# Certificate of Appropriateness

2742 W. STATE ST., **Concordia Historic District, City Of Milwaukee, owner**

PTS ID 73475 COA, exterior repairs

East Elevation

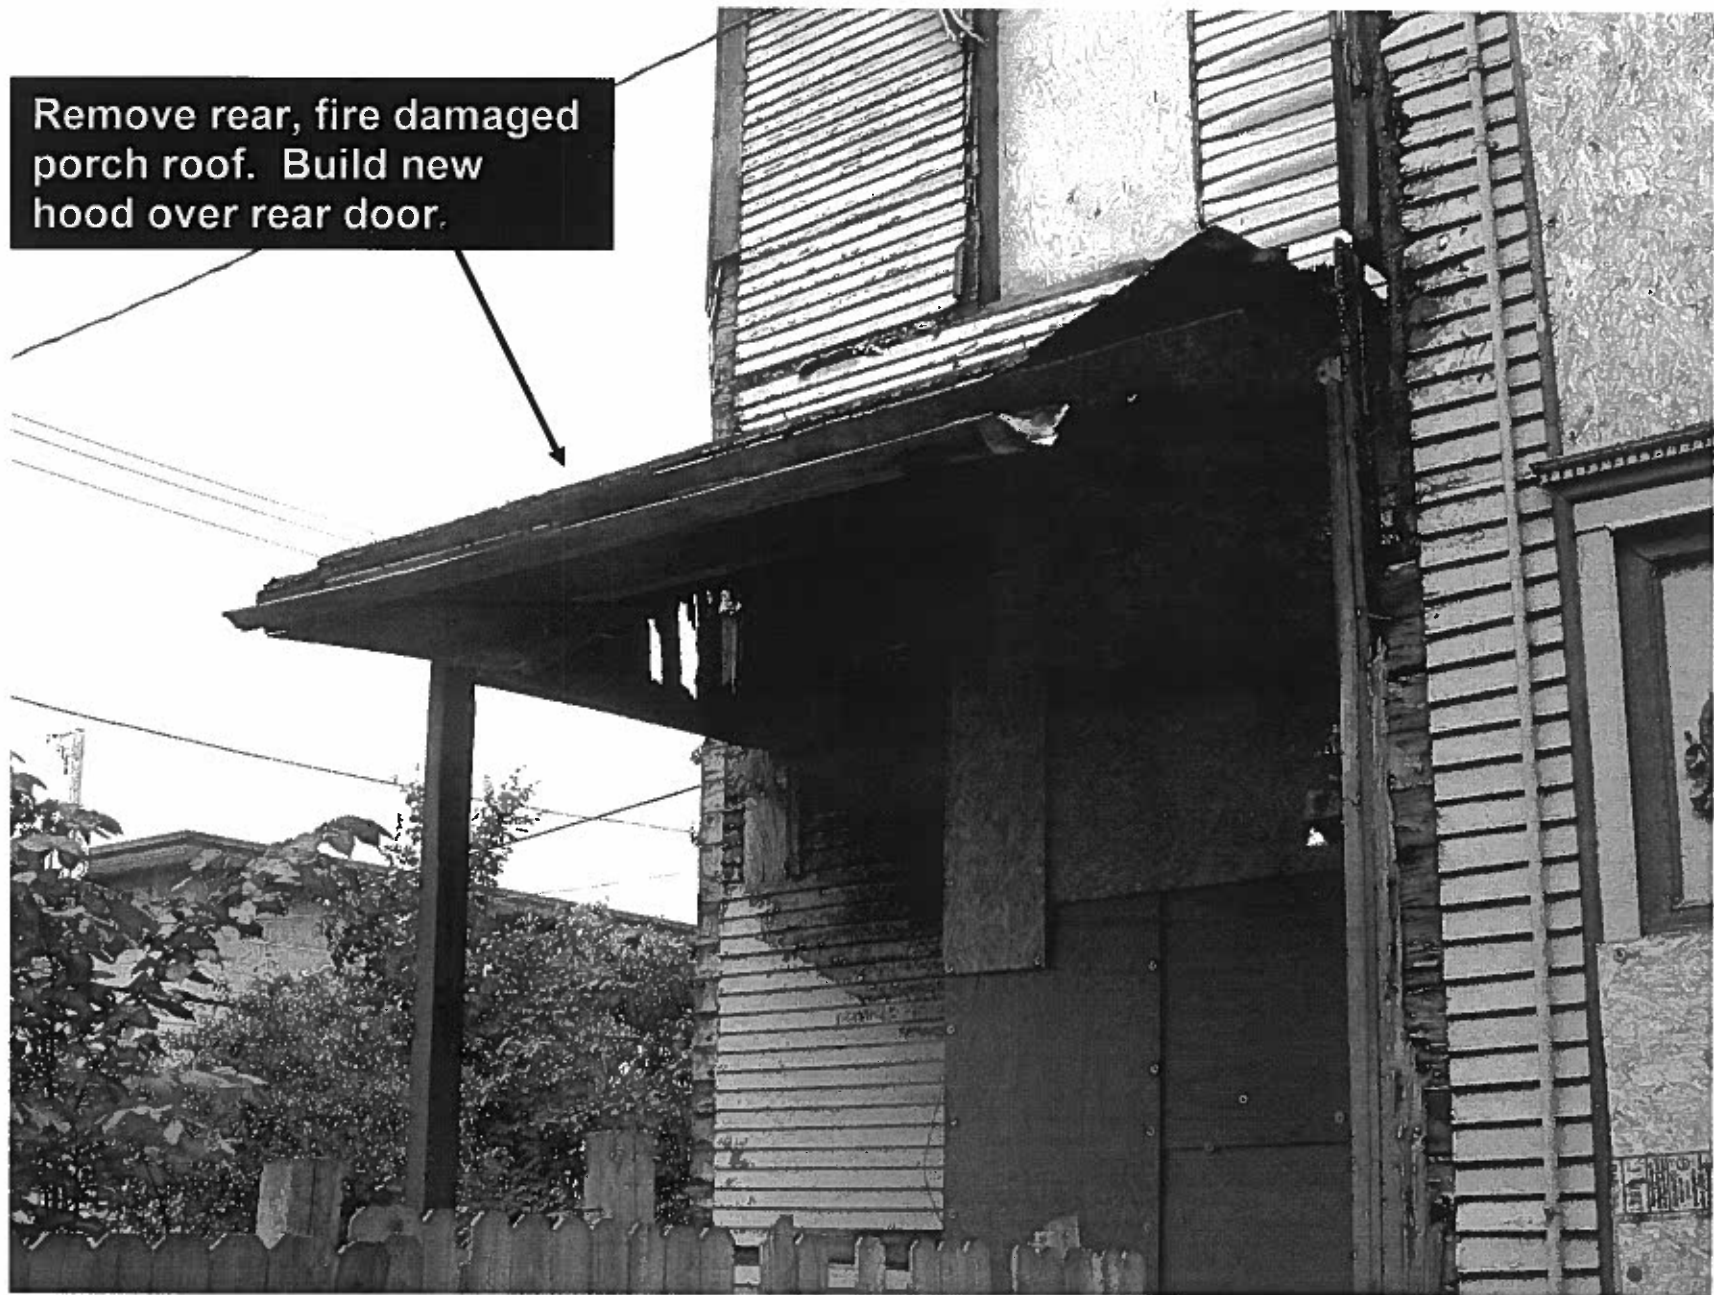
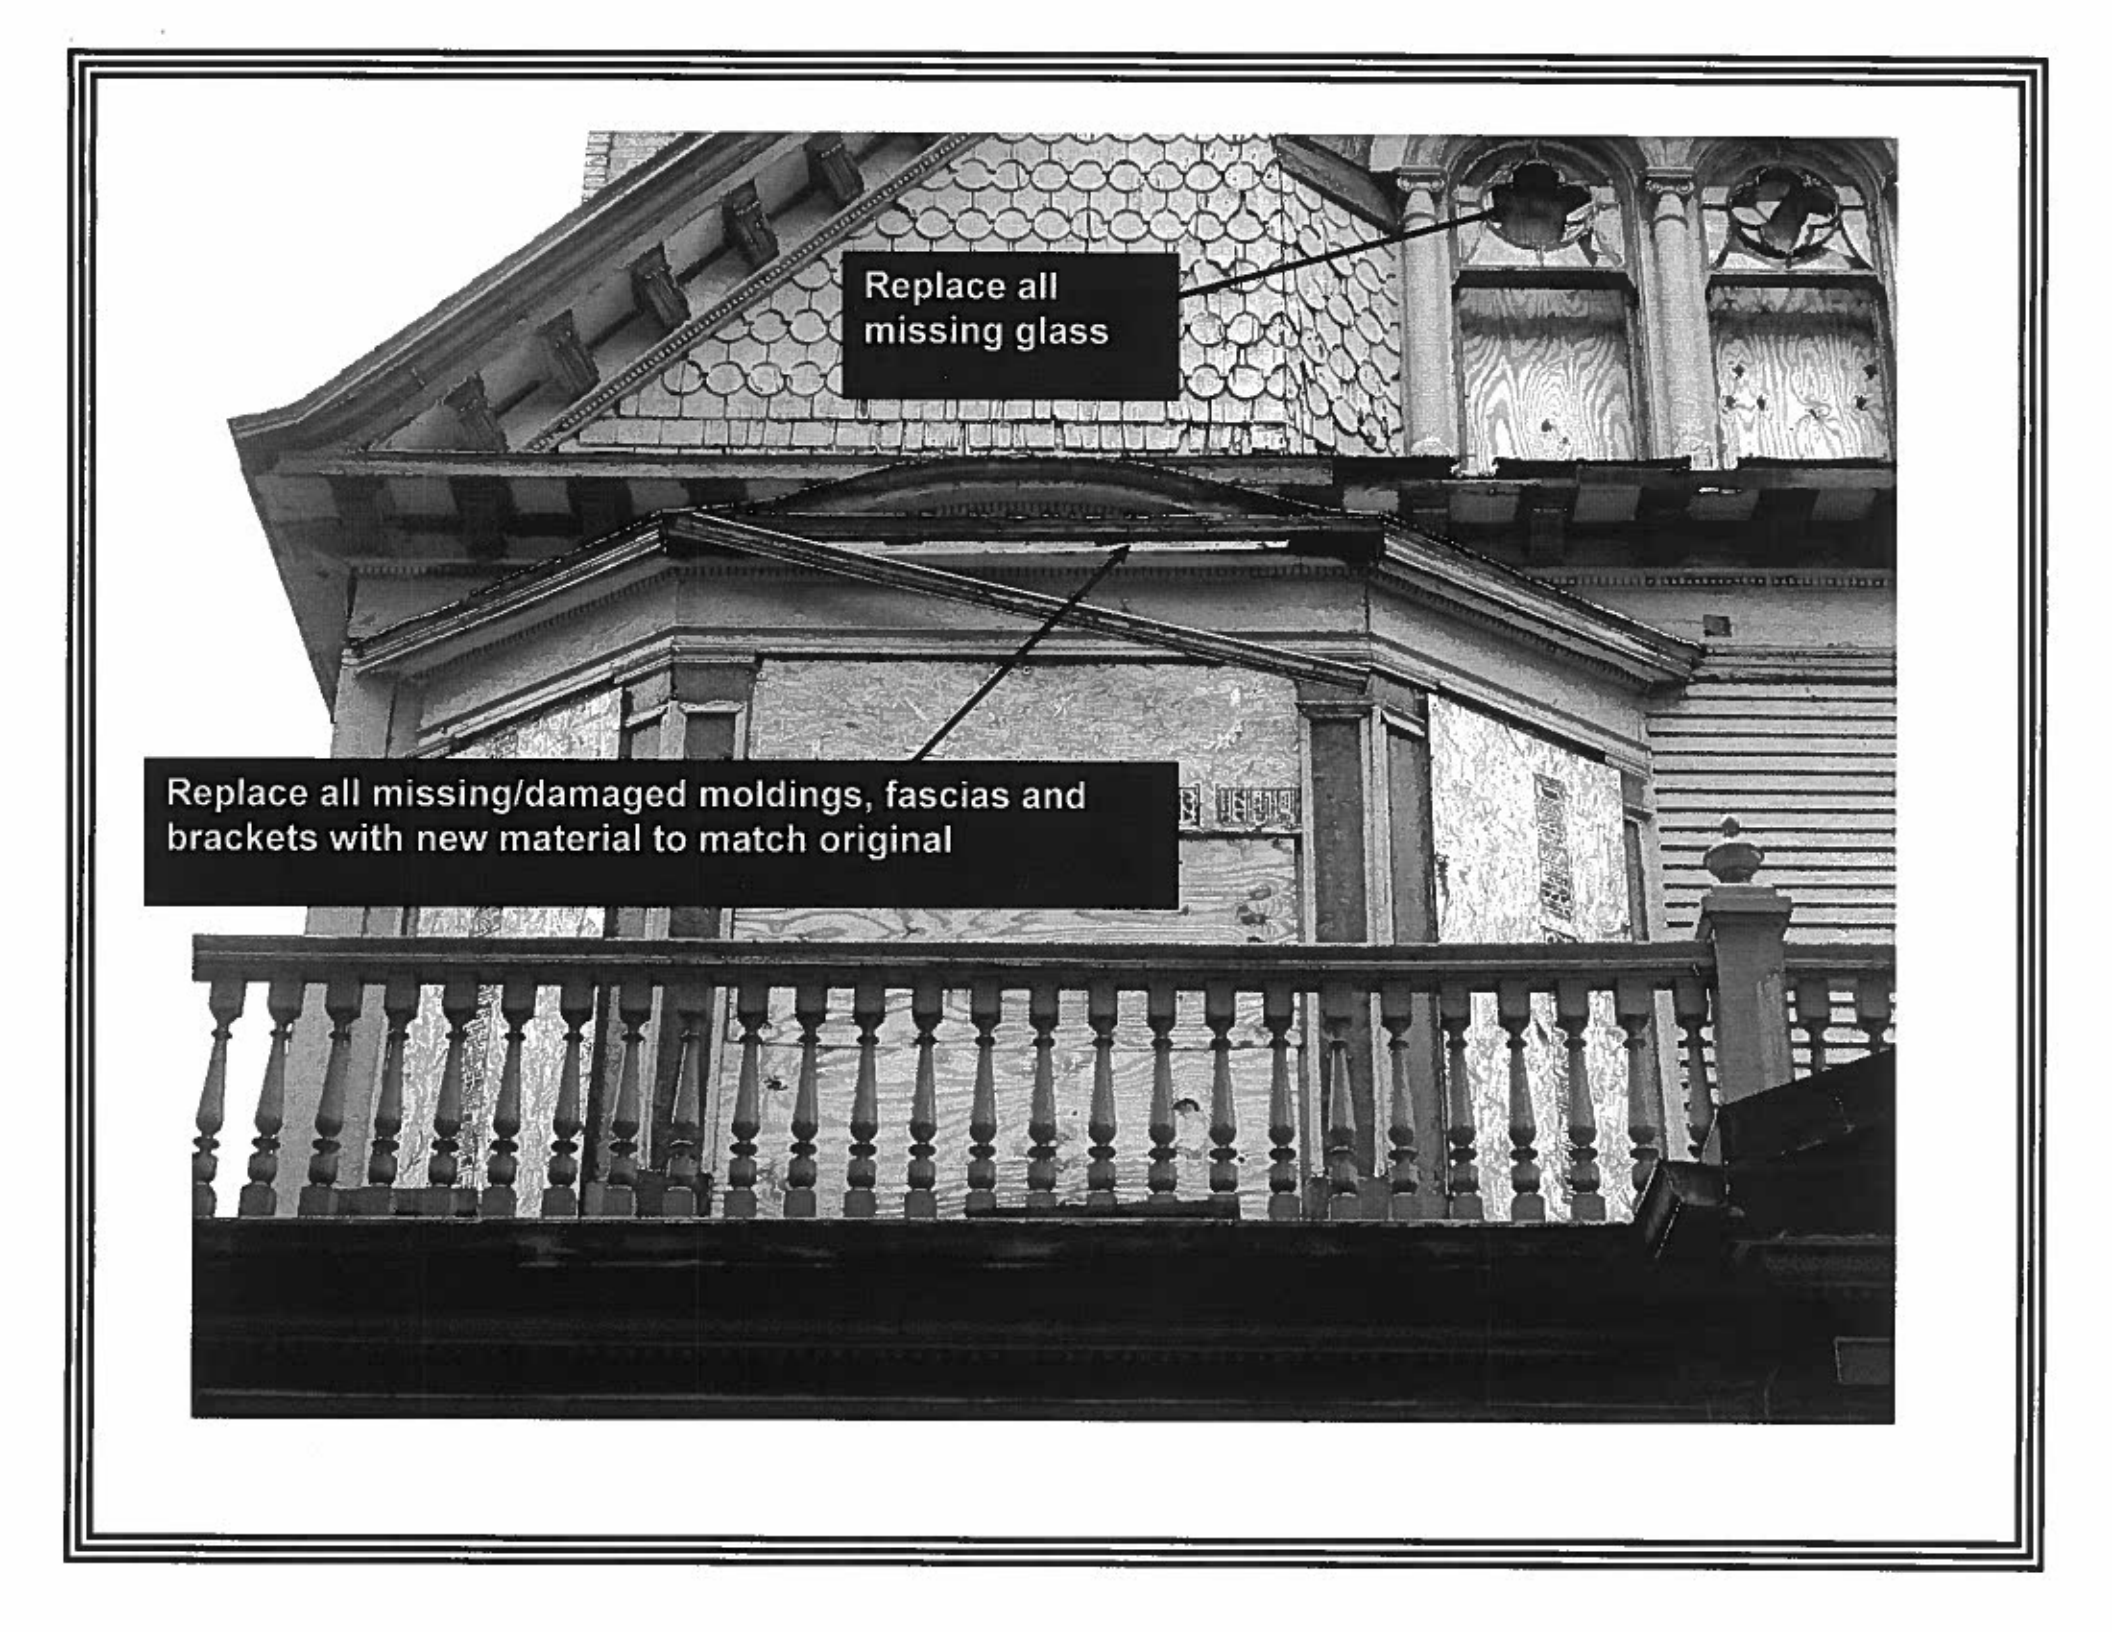
Replace existing, non-original shingles on tower with new, clear shingles laid in even courses to match the exposure of the shingles in the side gables. Repair/replace missing and broken tower windows.

This area to be patched  
in with new radially-  
sawn clapboards to  
match the existing  
profile and exposure

Remove rear, fire damaged porch roof. Build new hood over rear door.

Replace all missing glass

Replace all missing/damaged moldings, fascias and brackets with new material to match original

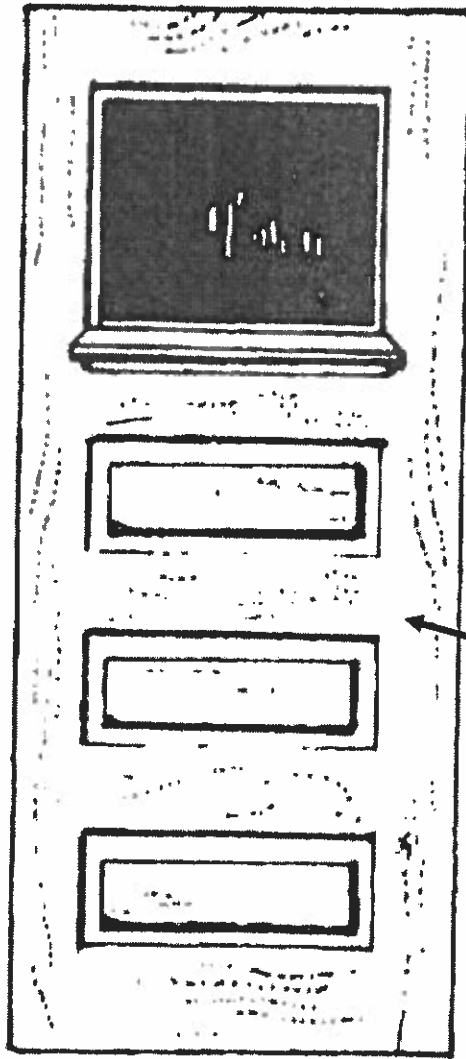
Tongue and groove, also called center-match flooring to be installed on front porch deck. Note direction of floorboards.

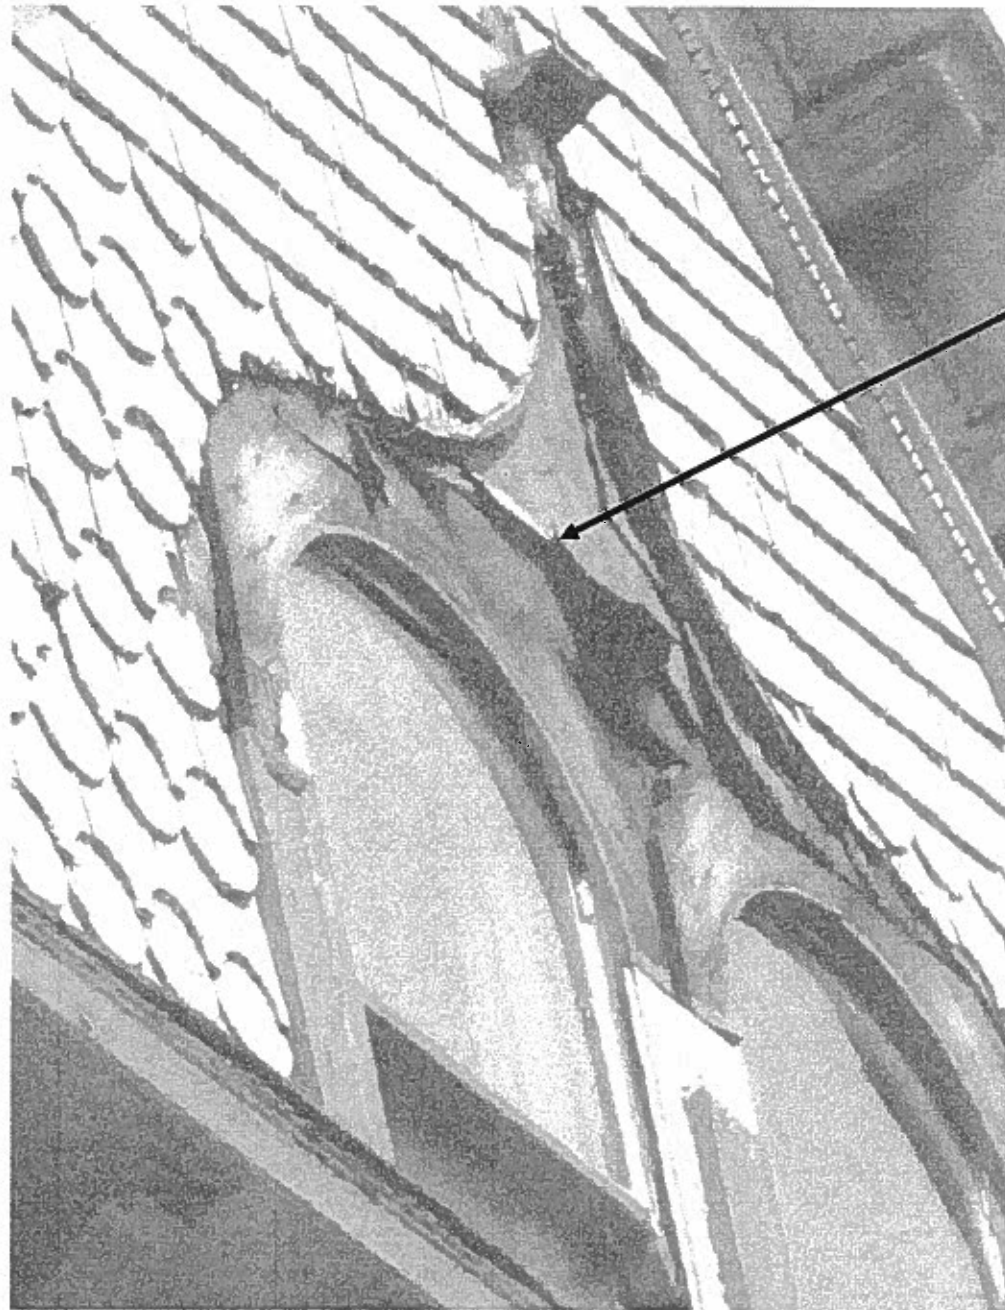
**Front concrete steps and service walk to be replaced with new concrete in same footprint.**

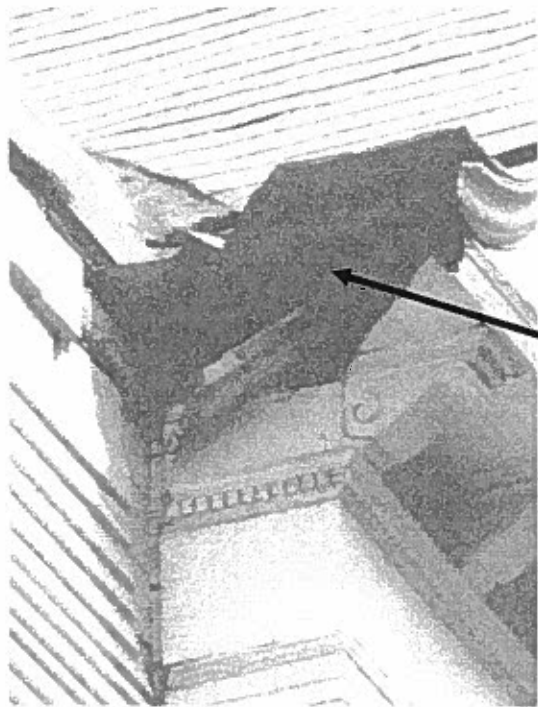
Fire damage on north elevation  
to be repaired with new,  
radially-sawn pine clapboards

15. Missing soffit and fascia on southeast corner of east side gable.

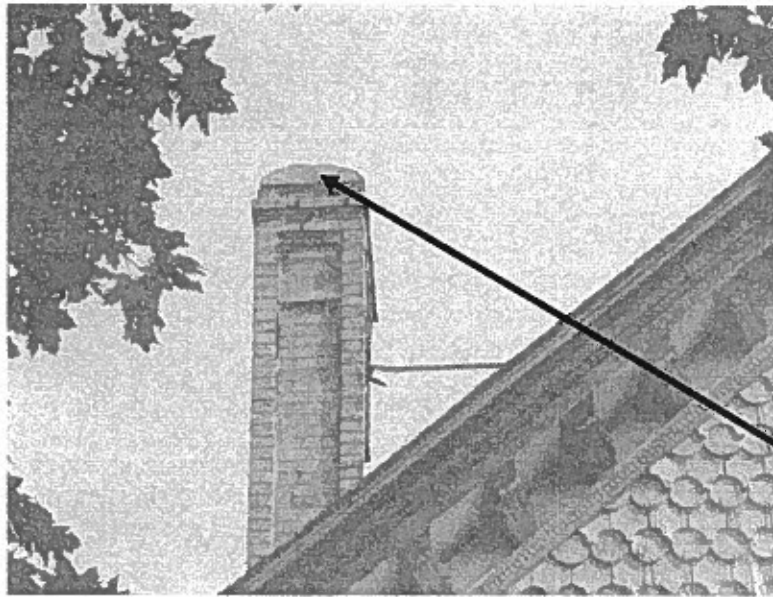
Missing window top to be replaced to match the similar existing window tops of the same design on the house

Rebuild damaged and missing soffit, fascia and trim where needed. Rebuild built-in rain gutters as needed. All molding profiles and original designs must be duplicated exactly.

3. Front elevation chimney on west roof

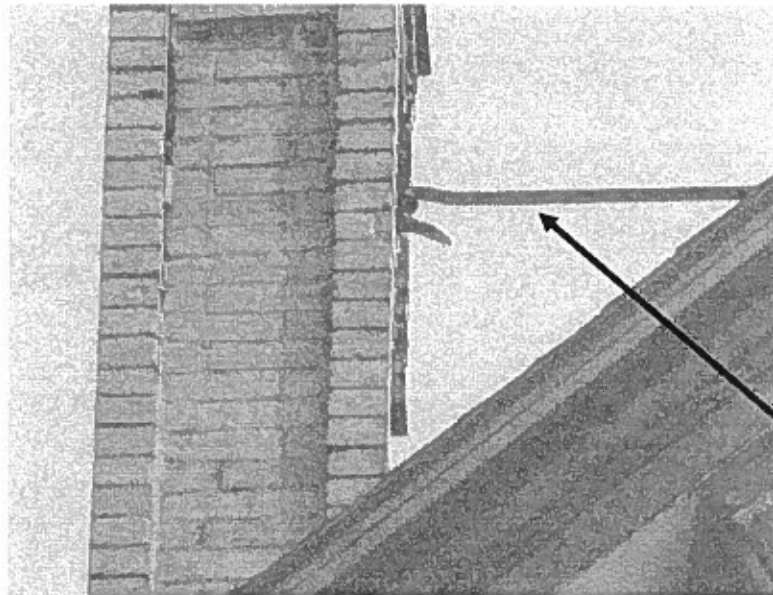
Front chimney to be cleaned and tuckpointed/rebuilt as needed. All new mortar must match the original in terms of joint, width, finish, texture and color. A stone cap, 3-1/2" in thickness, to overhang the course below it by 1 inch may be installed at the top the chimney in place of the existing concrete cap.

4. Front chimney connection with tie bar and hook

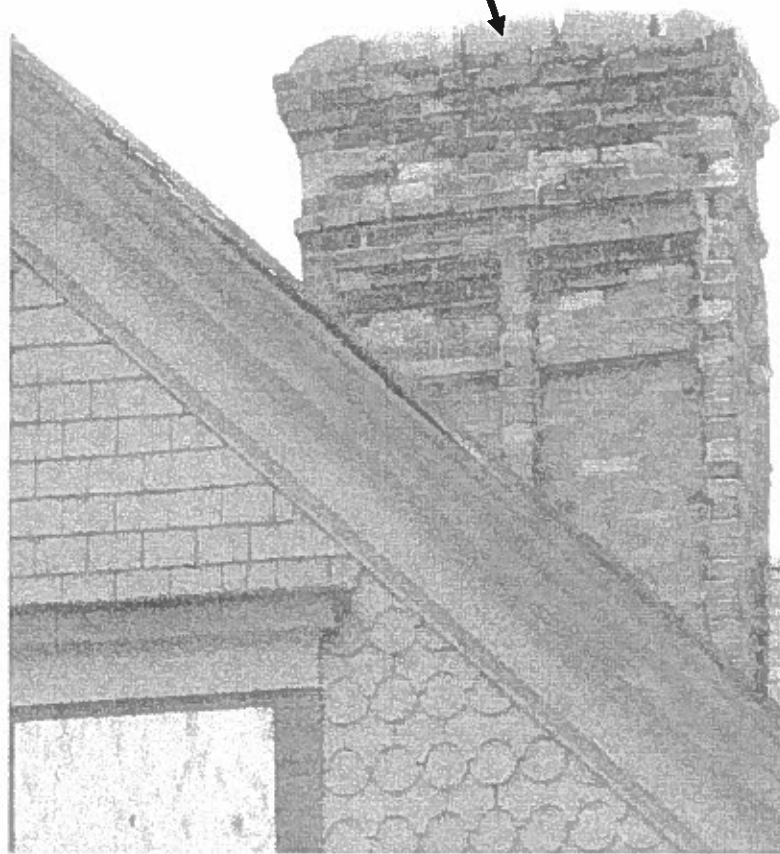
Hook must be preserved in its original location

Remove existing cap  
and replace with stone

7. Rear chimney taken from north side of building

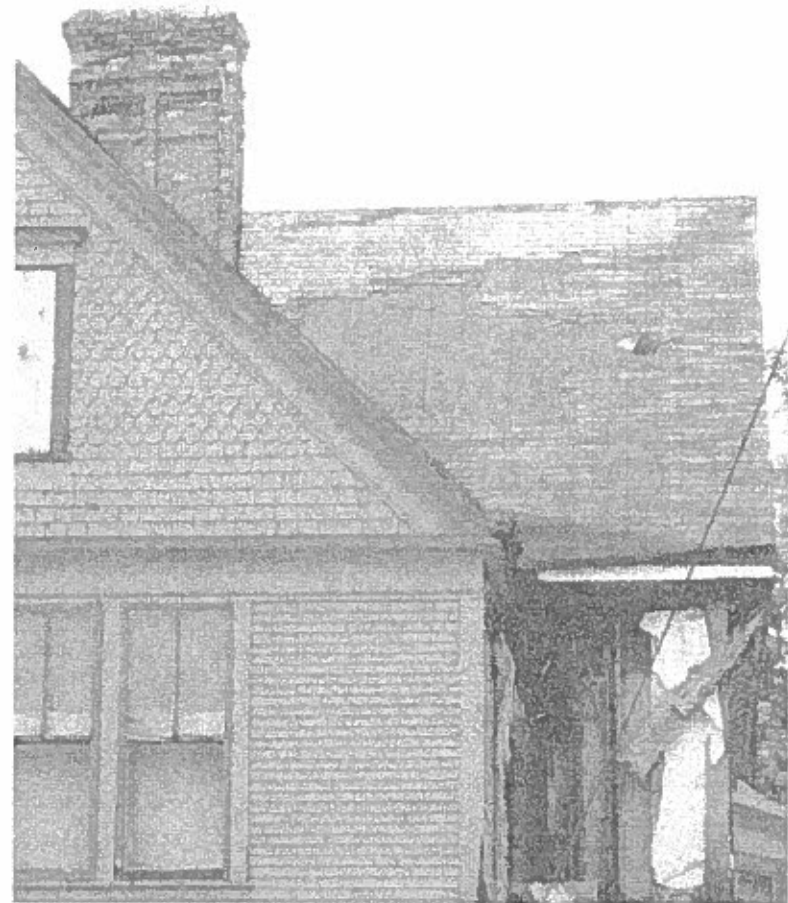
Rear chimney must be preserved in its original design. It can be tuckpointed and cleaned using a chemical cleaner and a hot water wash (no baking soda, walnut shells or other abrasives are permitted). The top of the chimney should be fitted with a stone cap, 3-1/2" in thickness that overhangs the brick course beneath it by one inch.
